CUSTOMER DRAWING

NAME
HD MATenet 1+6 SWS. GRP D
HD MATenet 1+6 EDS. GRP D

DRAWING NO.
ZEICHNUNGS-NR.
9-2334941

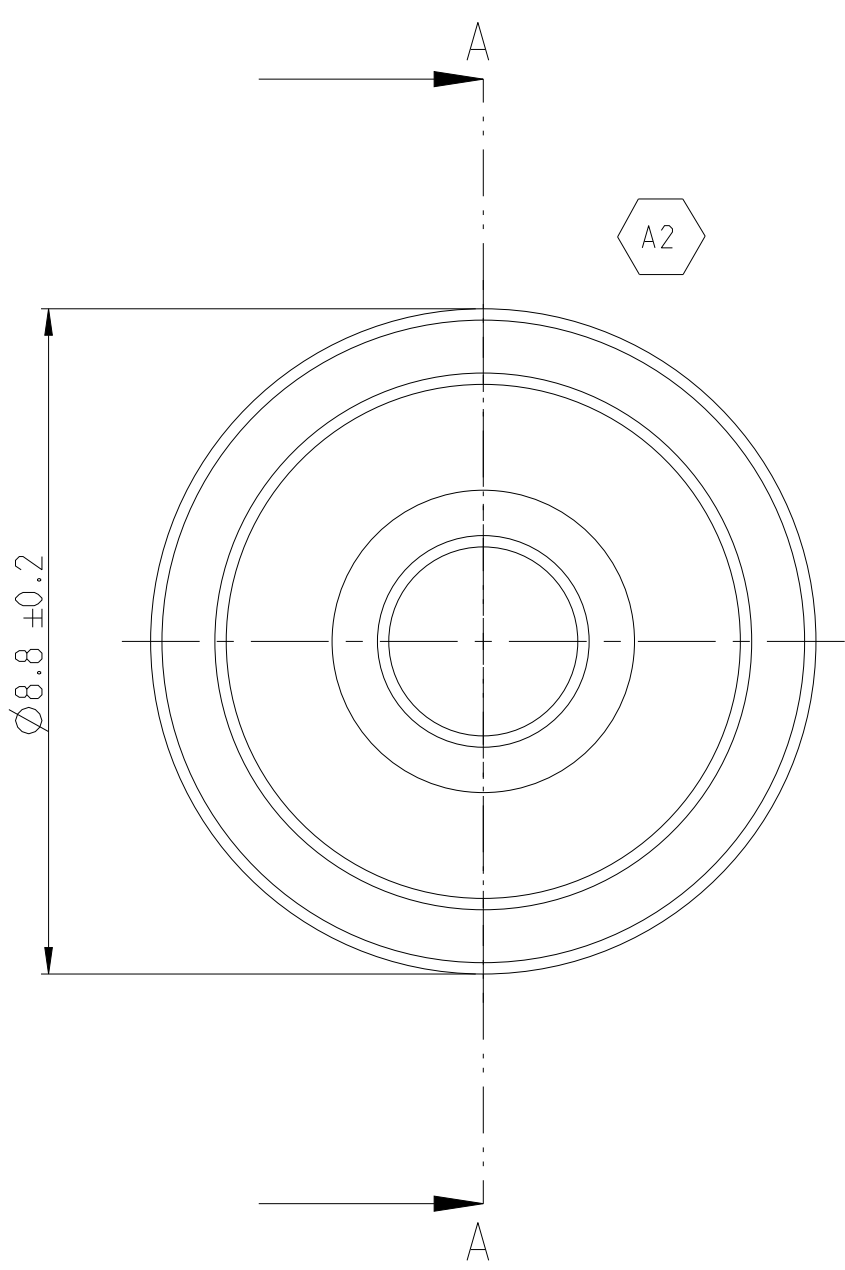
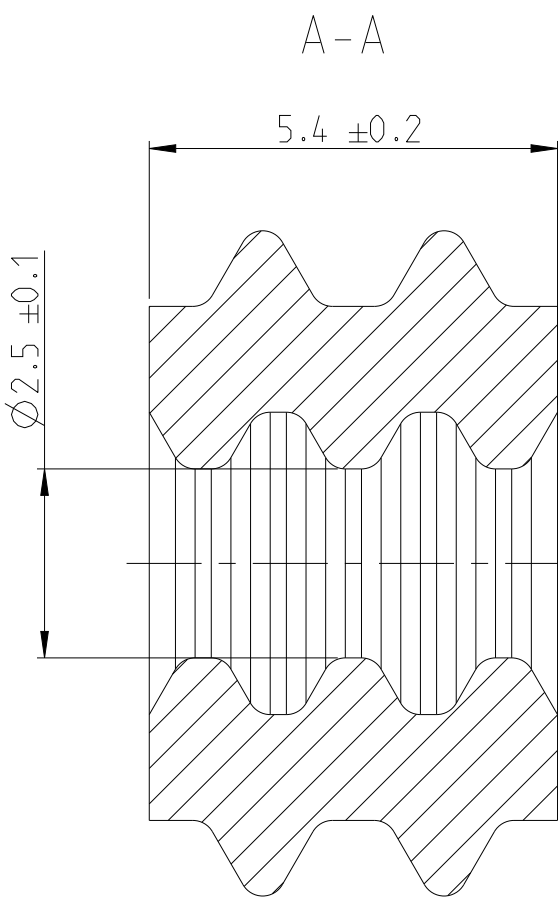
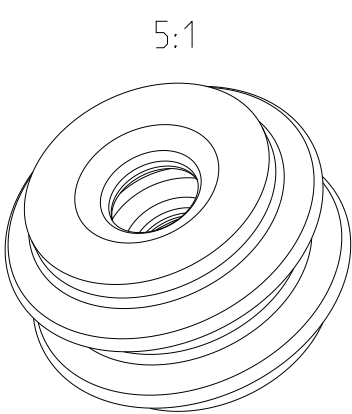
~~TE ORDER NUMBER AND REVISION~~
~~TE Bestell-Nummer und Revision~~
- A2

~~MOLD CAVITY MARKING~~
~~Nestmarkierung~~
- 3
